IFB No. 20-01 Security Cameras at Auburn H.S. and Guilford H.S.

RE: **ADDENDUM NO. 1**

ADDENDUM ONE

Project: **20-01 SECURITY CAMERAS AT AUBURN H.S. AND GUILFORD H.S.**
ROCKFORD PUBLIC SCHOOLS
ROCKFORD, ILLINOIS

ADE1.1

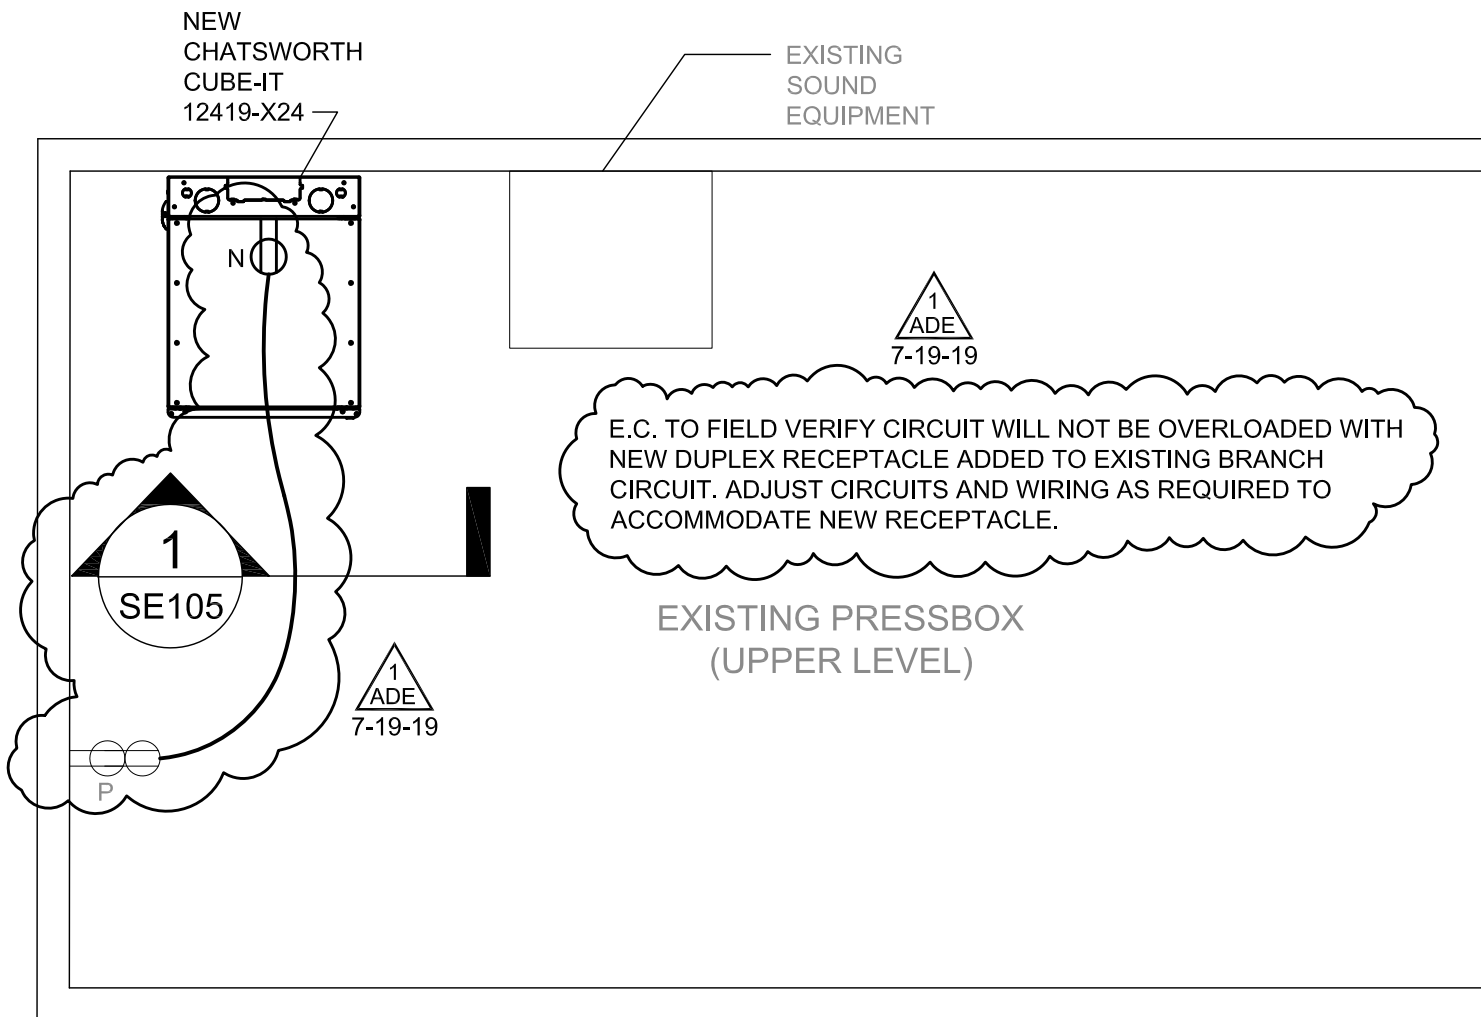
- 2.1. Revise Auburn High School Camera Schedule as shown on attached Sheet ADE1.1. All 180 Degree Cameras on this Sheet shall be Axis Q3708-PVE.

DATE: July 19, 2019 **ADE1.2**

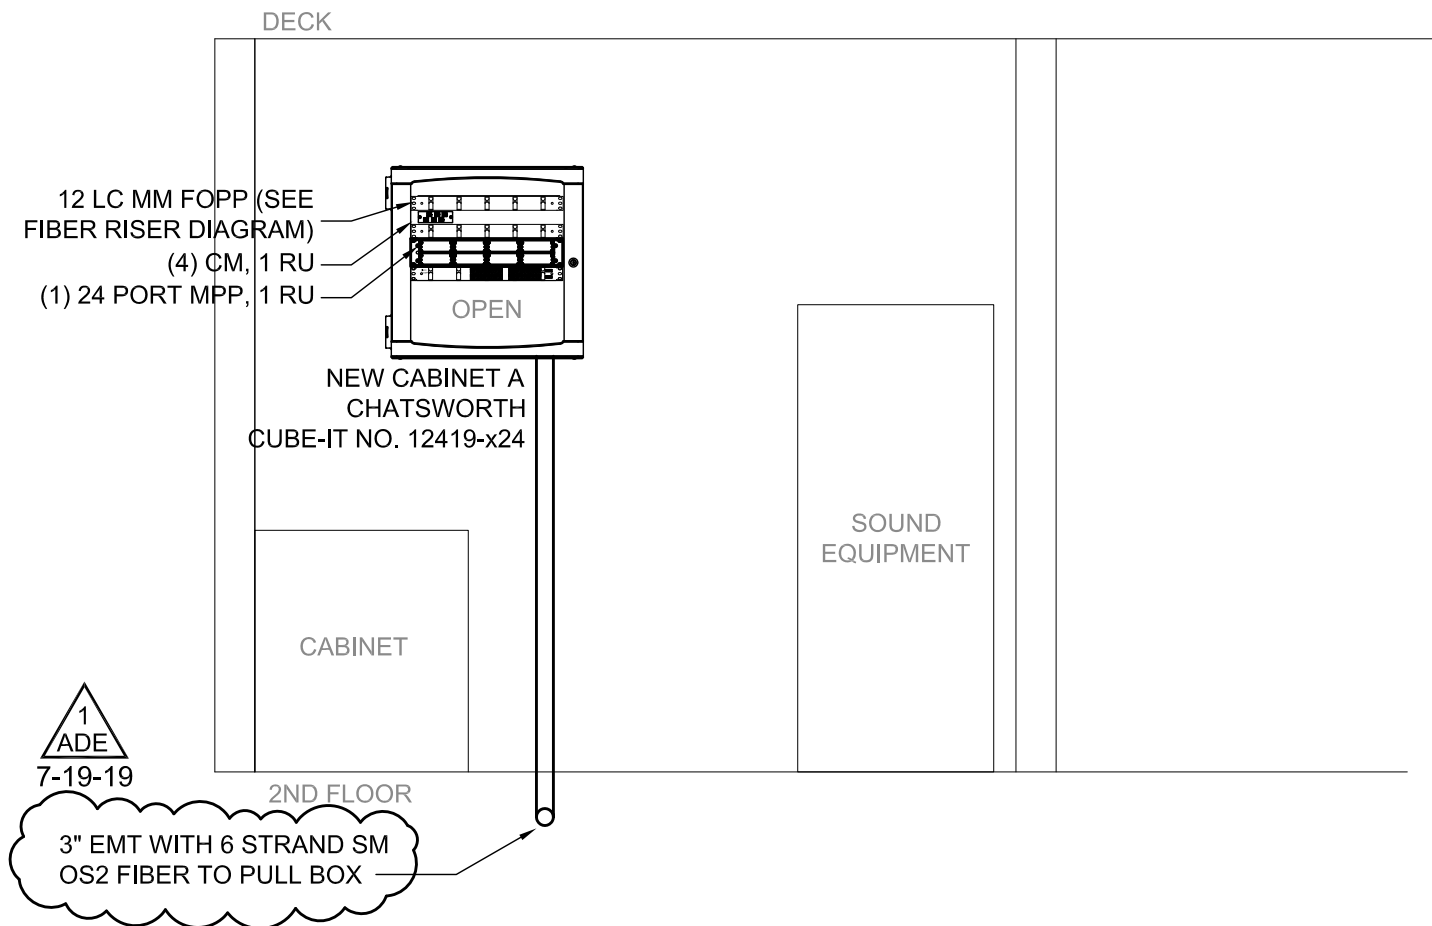
- 3.1. Add one 120V duplex receptacle installed in the new cabinet at the Guilford HS pressbox as shown on attached Sheet ADE1.2.

DATE: July 19, 2019 **ADE1.4**

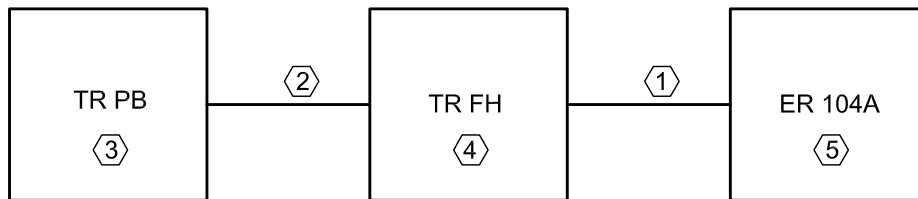
- 4.1. Revise Fiber Riser Diagram and Note on Detail 1/SE105 as shown on attached Sheets ADE1.3 and ADE1.4. The Fiber cable from the IDF (TR FH) to the stadium cabinet (TR PB) shall be outdoor rated 6 strand singlemode OS2 fiber. Fiber cable from IDF (TR FH) to the MDF (ER104A) shall be indoor rated 6 strand multimode OM3 fiber.

- ① NEW INDOOR RATED 6 STRAND OM3 FIBER IN INNER DUCT ROUTED THROUGH EXISTING PATHWAYS; TERMINATE EXISTING FOPP WITH NEW LC TYPE CASSETTE IN TR FH AND NEW C TYPE FOPP IN ER104A.
- ② NEW OUTDOOR RATED 6 STRAND OS2 FIBER, TERMINATE AT NEW LC TYPE FOPP IN TR PB AND EXISTING FOPP WITH NEW LC TYPE CASSETTE IN TR FH.
- ③ NEW CABINET AND FOPP - SEE DETAIL 1 - SE105
- ④ NEW FOPP IN EXISTING CABINET - SEE DETAIL 2 - SE105
- ⑤ NEW FOPP IN EXISTING RACK - SEE DETAIL 3 - SE105
